**Re: Revised Submission
NPDES Reissuance (Submission #2DM-ZEC4-66B7)
Saginaw Nodular Iron, 2100 Veterans Memorial Parkway, Saginaw, MI**

Attachment B – Revised Site Figure

SITE MAP
FOR SWPPP

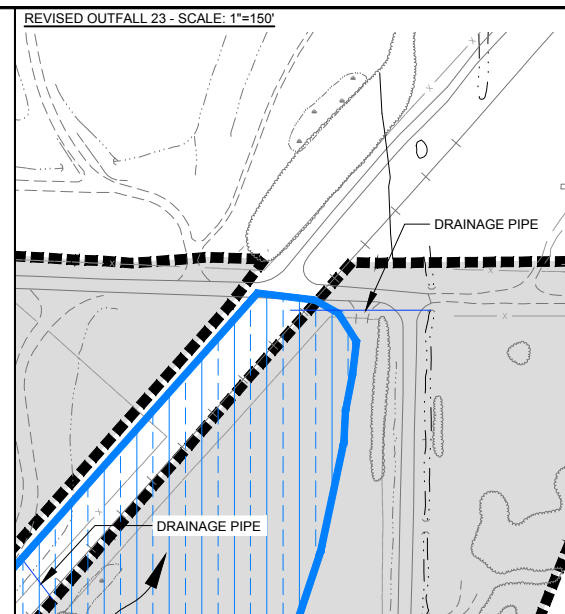
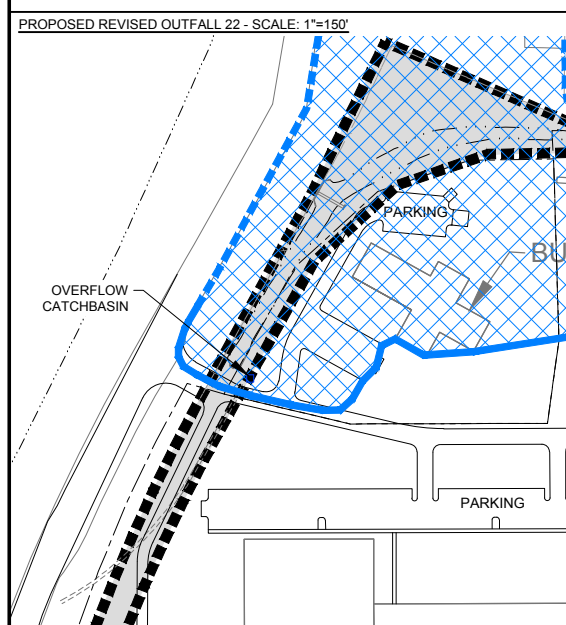
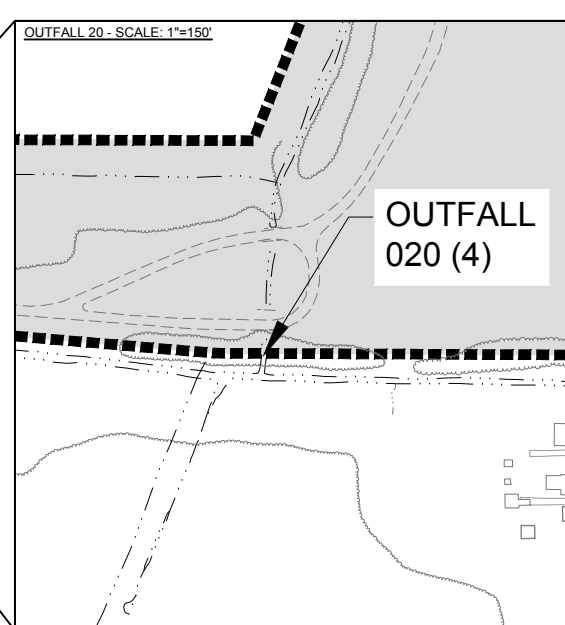
The purpose of adding the new outfall (Outfall 024) is to allow for controlled discharge from the east portion of the secondary pond, in the event the secondary pond is subdivided to assist in remediating the secondary pond sediments or if the water level in the pond needs to be lowered more rapidly than would otherwise occur through the current outfall (021).

- Revised Attachment 1 – Narrative Description – outfalls, to include a description of the new outfall (A clean copy will be uploaded to the miwaters website and a redline of the changes is included in Attachment A to this letter)
- Revised Site Figure, to include the location of the new outfall (See Attachment B)
- Under Section IIIA. Facility Information – Industrial / Commercial Facilities, subpart A.3 Discharge Types, revised table column 1, row 7 from, “Regulated Storm Water (Outfall 021)” to “Regulated Storm Water (Outfall 021 and 024)”

OUTFALL 021 AND
OUTFALL 024(4)
(CONTROLLED
OVERFLOW FOR
SECONDARY POND)

- Outfall 24 – RACER is currently evaluating options to remediate sediments in the Secondary Pond. As such, a new 1-ft diameter PVC pipe was installed in the embankment of the secondary pond (approximately 250 feet to the east of Outfall 21 and at approximately the same elevation) with a control valve to allow for controlled discharge from the east portion of the secondary pond in the event the secondary pond is subdivided to assist in remediating the secondary pond sediments or if the water level in the pond needs to be lowered more rapidly than would otherwise occur through Outfall 21. To date, the secondary pond has not been subdivided and therefore, the quality of the water that would be discharged through Outfall 24 is expected to be the same as that has been discharged through Outfall 21.
